September 26, 2017
Medway Planning and Economic Development Board
155 Village Street
Medway, MA 02053

Choate Park Site Plan:

Oakland Park:

MULTI FAMILY HOUSING
SPECIAL PERMIT
143 VILLAGE STREET
MEDWAY
MASSACHUSETTS

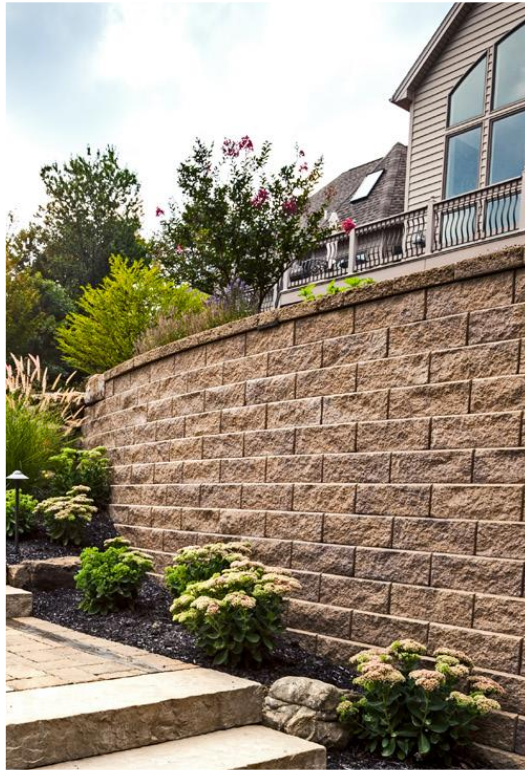
- The DRC recommends painting the existing garage doors another color and/or providing a decorative trim or architectural feature that would provide some color contrast between the existing garage door color and the siding color.
- The DRC suggests the shutters be painted black; all present at the September 11th meeting confirmed this color was acceptable.
- N.E. Premier Properties confirmed that there would be no exterior dumpster or trash enclosure. The condo owners will be responsible for bringing rollout containers to the curb for trash pick-up and back to the garages where they will be stored inside.
